Permit of Authorization to Construct an On-Site Sewage Facility Permit Valid For One Year From Date Issued

Permit Number: 118362

806 LOVETT RIDGE RD CITY OF BULVERDE, TX 78163

RE: 806 Lovett Ridge Rd. Centennial Ridge 1 Lot 12 – Block 1

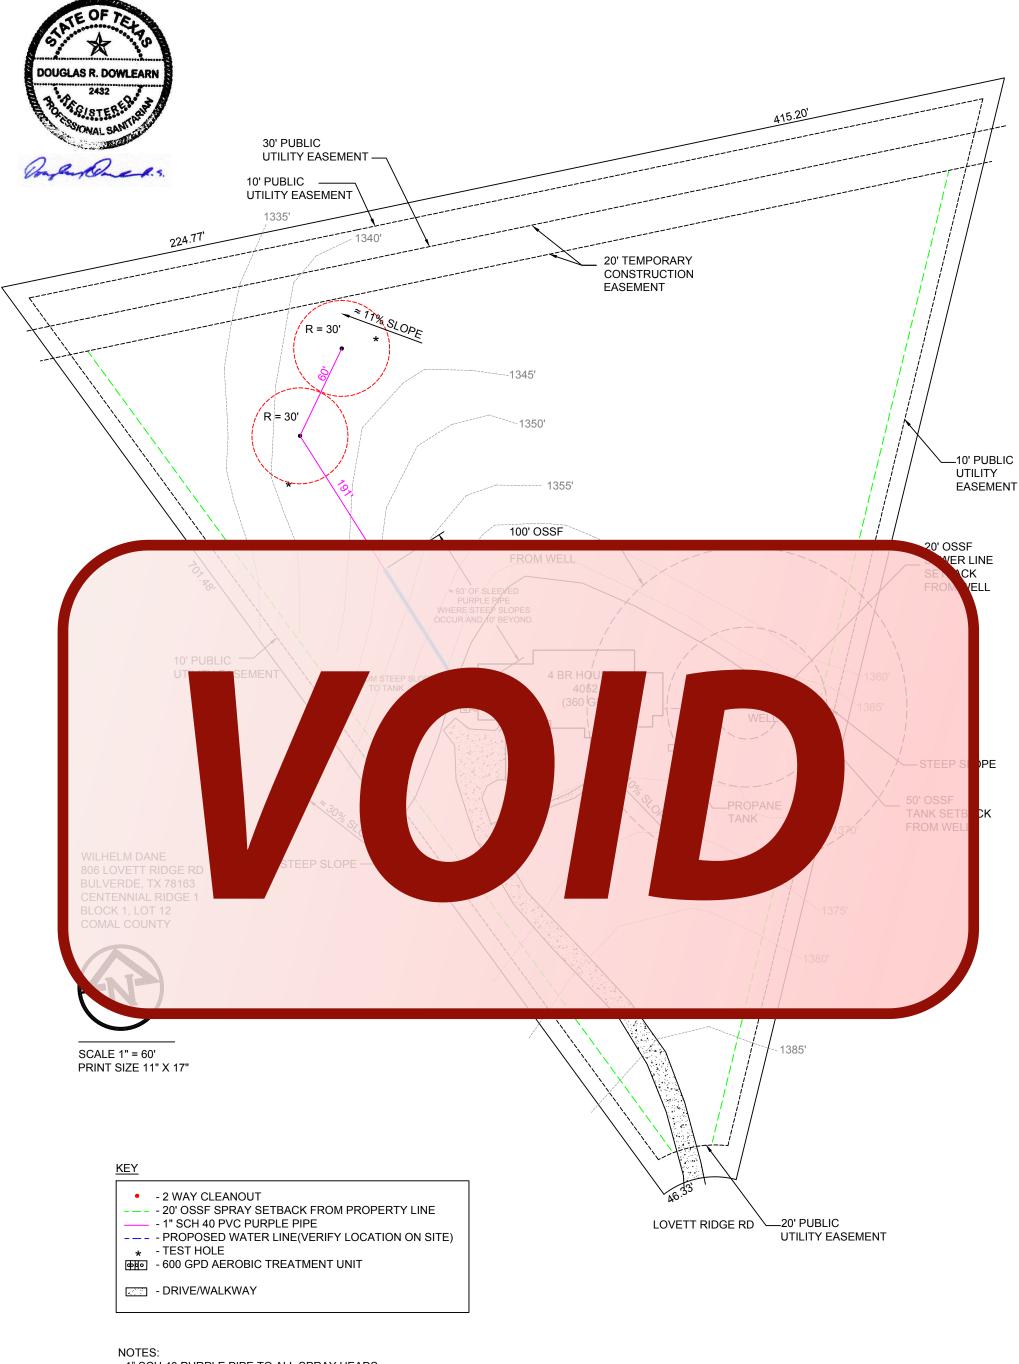
- Site Plan:
 - a. Show the east property line dimension.
- 3. Revise accordingly and resubmit.
